UNITED STATES PATENT AND TRADEMARK OFFICE

APPLICATION NO.	FILING DATE	FIRST NAMED INVENTOR	ATTORNEY DOCKET NO.	CONFIRMATION NO.
10/628,574	07/29/2003	Vittorio Bruno	2993-487US SC/ip	4086
32292	7590	03/10/2005	EXAMINER	
OGILVY RENAULT (PWC) 1981 MCGILL COLLEGE AVENUE SUITE 1600 MONTREAL, QC H3A 2Y3 CANADA			RODRIGUEZ, WILLIAM H	
			ART UNIT	PAPER NUMBER
			3746

Office Action Summary

**PRIOR ART****INVENTION**

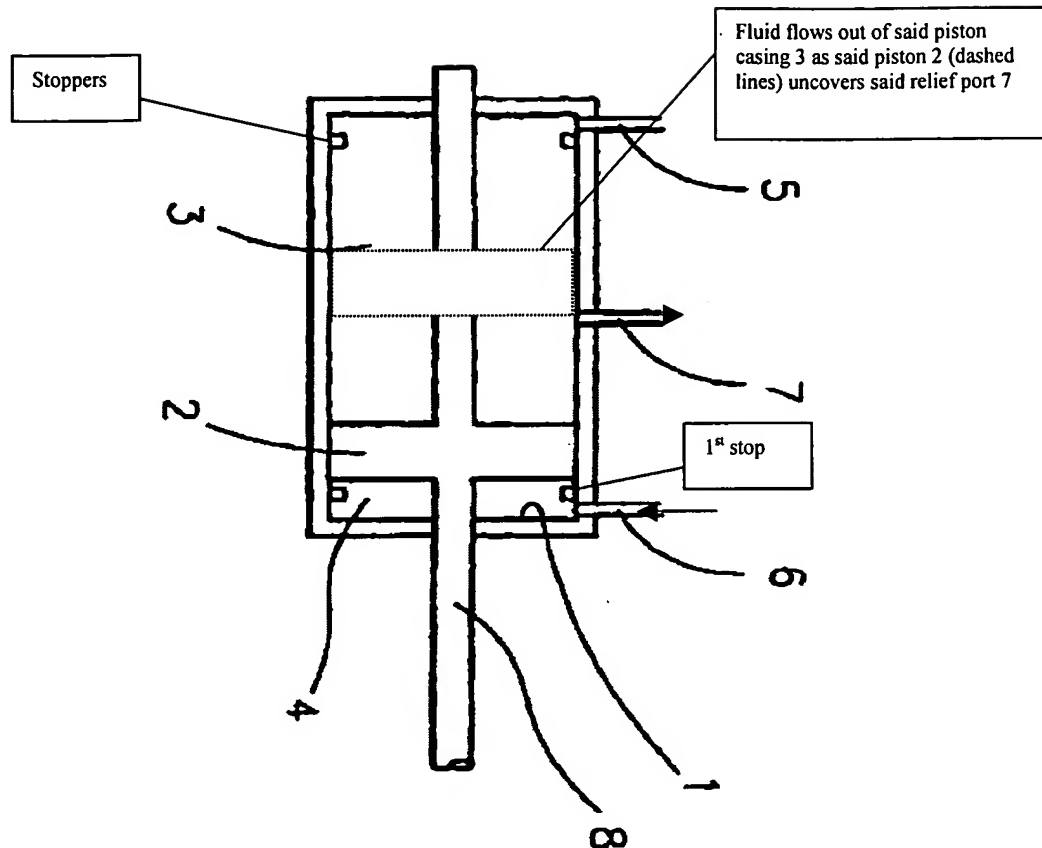
2. Claims 1-7, 10, 20, 21 and 23 are rejected under 35 U.S.C. 102(b) as being anticipated by Harvey et al. (EP 1054164 A2).

With respect to claim 1, **Harvey** teaches an actuator comprising a movable piston 2 in a piston casing 3, the piston 2 being movable to a predetermined axial position set by a relief port 7 which is selectively openable for allowing incoming pressurized fluid to flow out of said piston casing 3 as said piston 2 uncovers said relief port 7. See particularly **Figure 1**, column 1 lines 17-25, lines 29-34 of **Harvey**.

With respect to claim 2, **Harvey** teaches that the piston casing 3 has first and second opposed end portions, and wherein said relief port 7 is provided at a location intermediate said first and second opposed end portions. See particularly **Figure 1** of Harvey.

With respect to claim 3, **Harvey** teaches that the piston 2 is movable from one side of said relief port 7 to an opposed side thereof when said relief port 7 is closed. See particularly **Figure 1** of Harvey.

With respect to claim 4, **Harvey** teaches that the actuator further comprises a control port 6 provided at a first end portion of said piston casing 3, said control port 6 being connected to a first valve operable for allowing pressurized fluid to flow into and out of the piston casing 3. See particularly **Figure 1**, column 1 lines 11-12 of Harvey.

With respect to claim 5, **Harvey** teaches that said control port 6 and said relief port 7 are in fluid flow communication via said piston casing 3 when said piston 2 uncovers said relief port 7. See particularly **Figure 1** of Harvey.

With respect to claim 6, **Harvey** teaches that the piston 2 has a first face adapted to be exposed to fluid pressure, and wherein a first stop is provided in said casing 3 to stop said piston in a first limit position in which said first face of said piston is spaced axially from said control port 6. See particularly **Figure 1** of Harvey.

With respect to claim 7, **Harvey** teaches that the piston 2 is biased against said first stop. See particularly **Figure 1** of Harvey.

With respect to claim 10, **Harvey** teaches that stoppers are provided on either sides of the relief port 7 to physically set the limit positions of the piston 2. See particularly **Figure 1** of Harvey.

With respect to claim 20, **Harvey** teaches an actuator comprising: a piston 2 slidable in a piston casing 3 between first, second and third positions, said second position being intermediate said first and third positions, a first port 6 provided in said piston casing 3 for allowing a pressurized fluid to be selectively supplied into said piston casing 3 in order to displace said piston 2 from said first position to said third position, and a selectively openable outlet port 7 provided in said piston casing 3 at a location corresponding to said second position, whereby when said piston 2 uncovers said outlet port 7 and said outlet port 7 is opened, the pressurized fluid flowing into said piston casing 3 via said first port 6 is permitted to flow out of said piston casing 3 through said outlet port 7, thereby causing said piston 2 to remain in said second position thereof. See particularly **Figure 1**, column 1 lines 17-25, lines 29-34 of Harvey.

With respect to claim 21, **Harvey** teaches that the first port 6 and said outlet port 7 are in fluid flow communication via said piston casing 3 when said piston 2 uncovers said outlet port 7. See particularly **Figure 1** of Harvey.
